# 66103A-08A

# S E R V I C E N O T E

## 66103A DC Power Supply

**The instrument will not communicate or will not complete self test.**

Figure 1

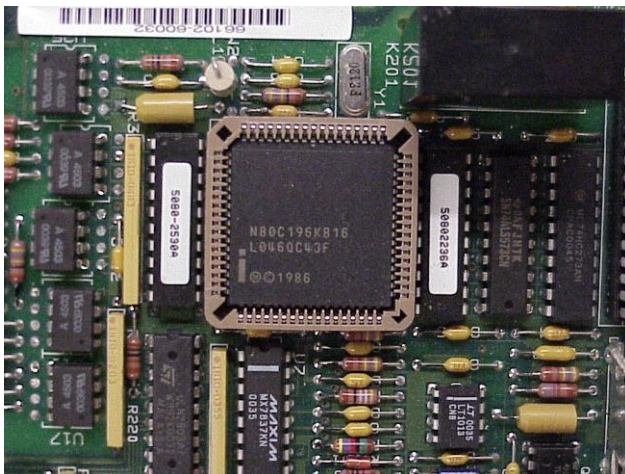
When the 16-Bit processor p/n1821-1474 is installed in the 68 pin PLCC SOCKET P/N 1200-1274 “U001” if there is not a gas tight connection between the processor pins and the socket pins an intermittent connection will occur.

The pin connections may not be reliable. Over time the pins may become intermittent which will cause the instrument not to communicate or not complete self test.

Figure 1 will help to identify the **68-PIN PLCC SOCKET location - P/N 1200-1274** (Circuit Reference “U001”)

Simply removing the 16-Bit processor p/n\_1821-1474 and reinstalling it will not insure a gas tight connection or guarantee that the instrument will be reliable. To insure reliability the socket must be removed and replaced.

Any Model having a serial number starting and ending with the serial numbers shown in the chart below should have the socket 68-PIN PLCC SOCKET - P/N 1200-1274 (Circuit Reference "U001") **REPLACED!**

**Figure 2**

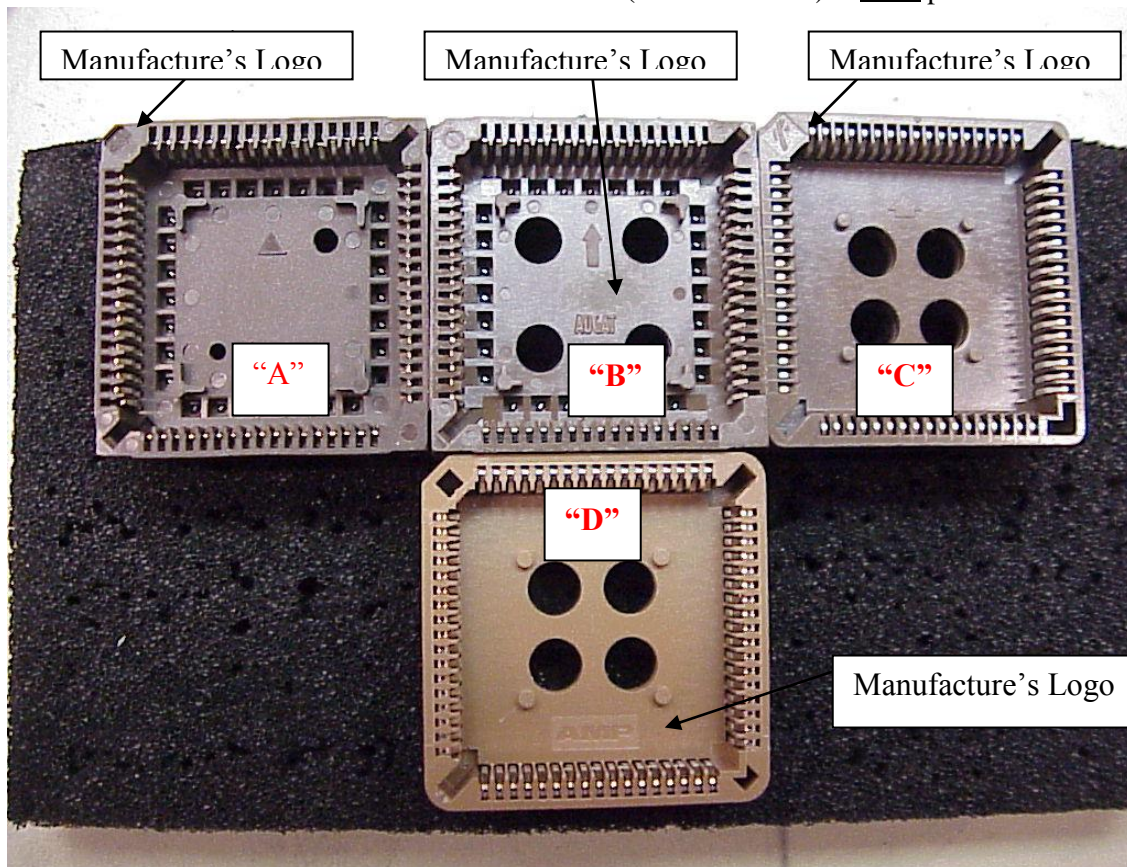
This figure should be used to identify **GOOD** sockets and a potential defective socket. The **16-Bit MCU 16 MHZ 68PLCC CMOS IC (P/N 1821-1479)** is **NOT** pictured.

The following information will help identify each socket type and manufacturer. The manufacturer's logo can be identified as shown. After the **16-Bit MCU 16 MHZ 68PLCC CMOS IC** has been removed there are also mold markings that can be easily viewed these markings should be used to identify a **Good or Defective socket**.

- Socket **"A"** is a sample of a GOOD AMP socket.
- Socket **"B"** is a sample of a GOOD Tyco/Augit socket.
- Socket **"C"** is a sample of a GOOD FCI socket.
- Socket **"D"** is a sample of a DEFECTIVE Tyco socket.

The sockets above labeled **"A", "B" or "C"** are good and should NOT be replaced.  
The socket above labeled **"D"** is considered defective should be replaced.

## Discipline “A” &amp; “B”

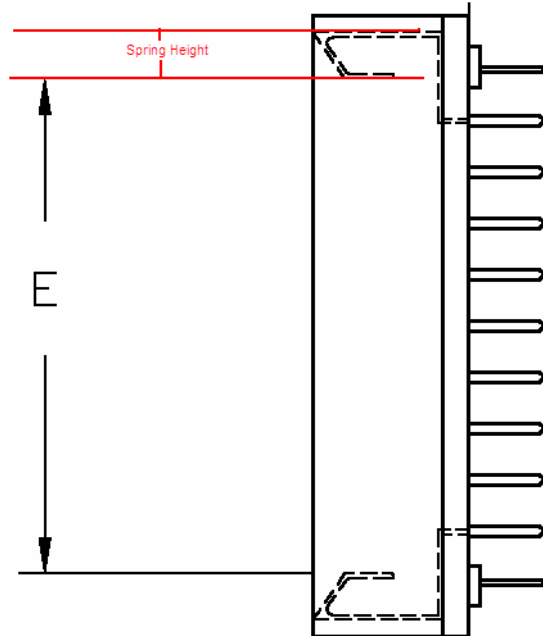
**Discipline A – Permanent Corrective Action Plan “The socket shown in the pictures are for reference ONLY”**

The condition of the recessed beams has been corrected by a design enhancement implemented in production. This design enhancement increased the spring height dimension by 0.04mm and decreased the spring height tolerance by 40%. The spring height dimension is shown in the drawing below.

This design enhancement is intended to position the contact beams closer to the middle of the socket and increase the normal force exerted on the contacts of the chips mated to the socket.

**Discipline B – Verification of Corrective Action “The socket shown in the pictures are for reference ONLY”**

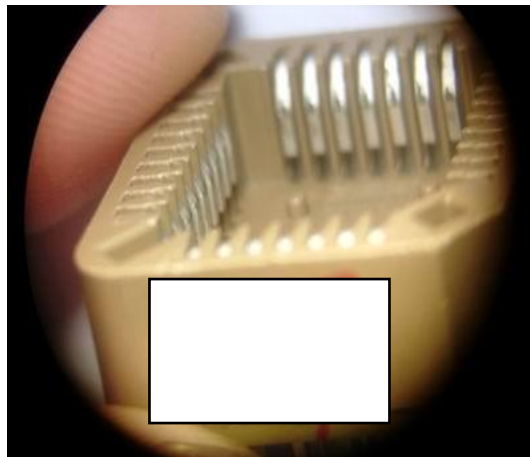
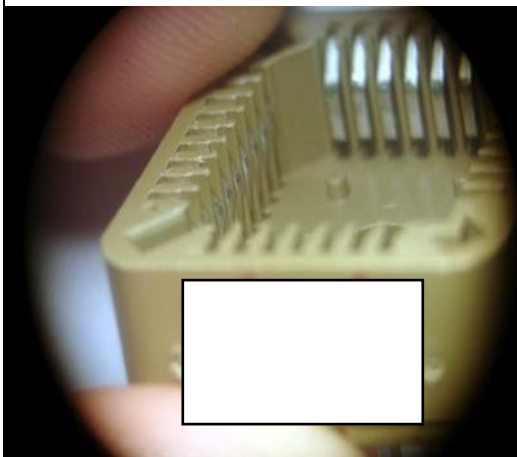
The effectiveness of this design enhancement was tested by comparing the mating and un-mating forces on the older and newer designs. The test results for sockets with the increased spring height (newer design) showed an increase in the mean mating force of 18.9% and an increase in the mean un-mating force of 23.4%. The increase in the un-mating force test results between the old design and the new design indicate that a greater normal force is being exerted on the test chip contacts by the socket contact beams. The two revisions of this contact beam design were visually examined after the mating and un-mating force testing. Photos of the two sockets are shown below. The photo on the left shows the older version socket prior to the enhanced contact beam design. The photo on the right shows a socket with the design enhancement. The contacts with the older design appear to be recessed farther into the housing after un-mating.

Material with this design enhancement will be labeled with a 2007 date code
